American Champion Aircraft Corp.  
Rochester, WI 53167

Service Letter: 430, Revision A

Date: March 05, 2008

Title: Conversion of 7ECA, 7GCAA and 7GCBC to Lycoming O-320-B2B or Equivalently Provisioned Engine per TCDS E-274.

Figure 1, Firewall Modifications

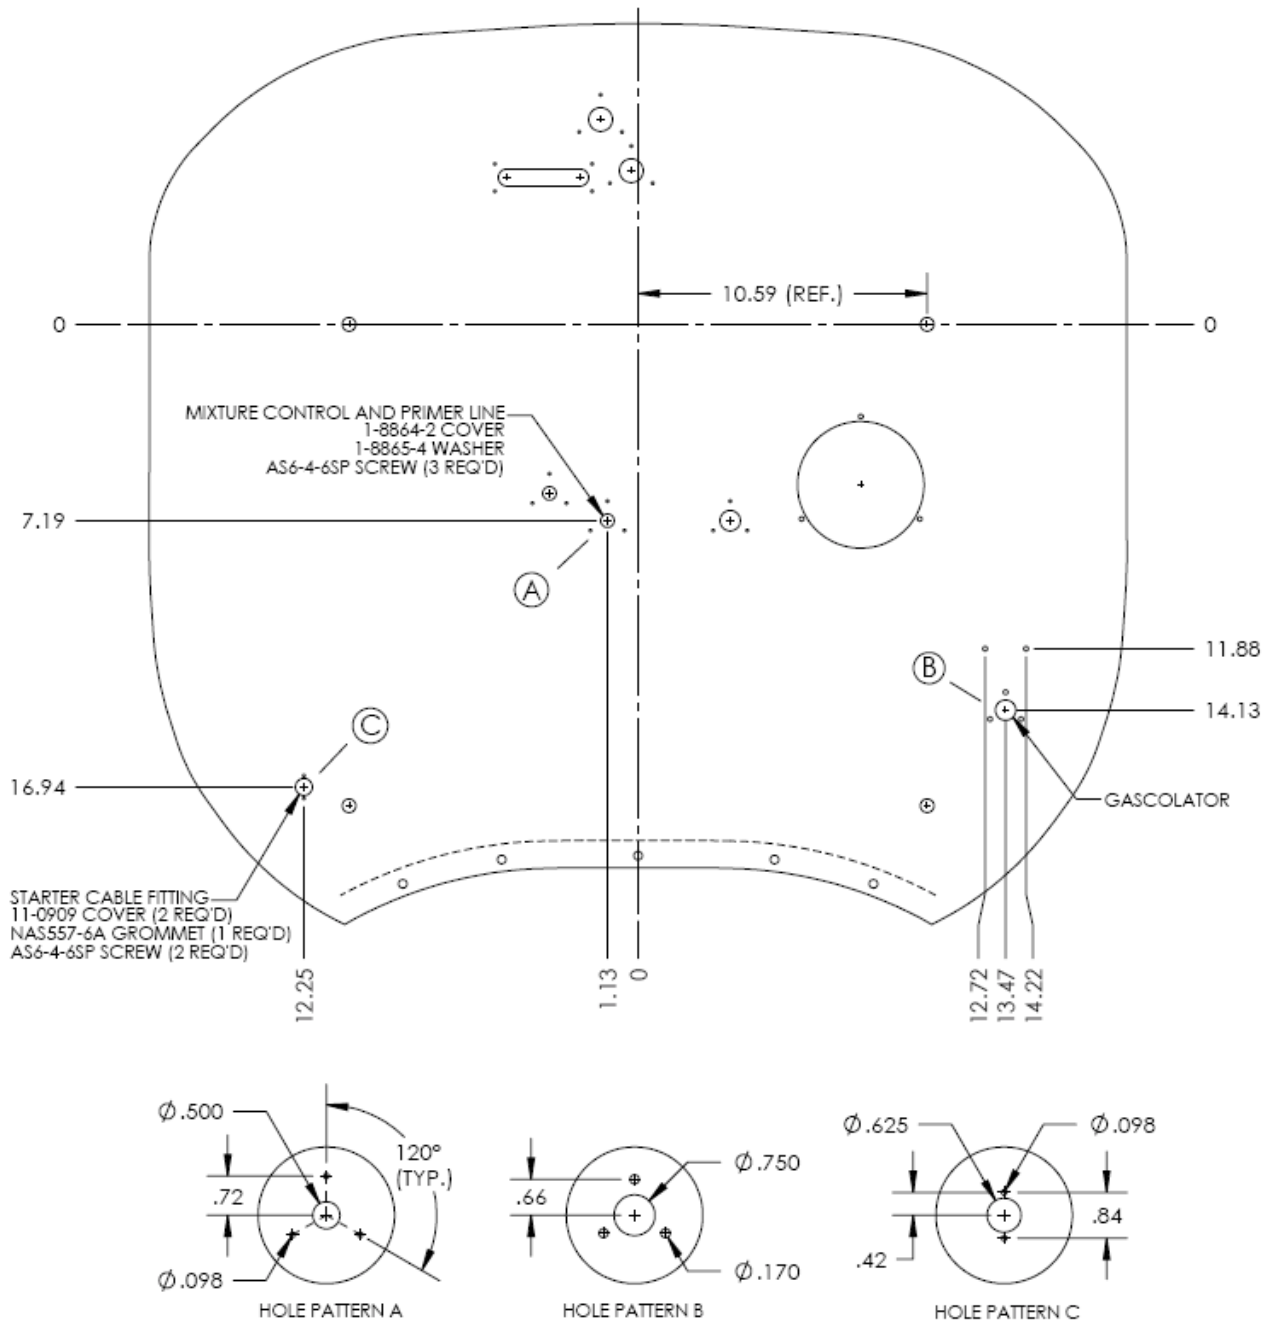
Replace and relocate gascolator. See figure 1 for correct placement of the new gascolator. Replace carburetor fuel line with Aeroquip hose 624000-8D-0154. Replace fuel valve bracket with 11-0831 per ACAC drawing 7-1290. Components from the gascolator to and including the fuel manifold must also be replaced; install components per ACAC drawing 7-1476.

The existing 4-1640 firewall must be modified with the addition of the three hole patterns shown in figure 1, or replaced with a new 4-1640-4 firewall. Plug any unused holes with 1-8864-6 cover, 1-8865-4 silicone washer and AS6-4-6SP screws.
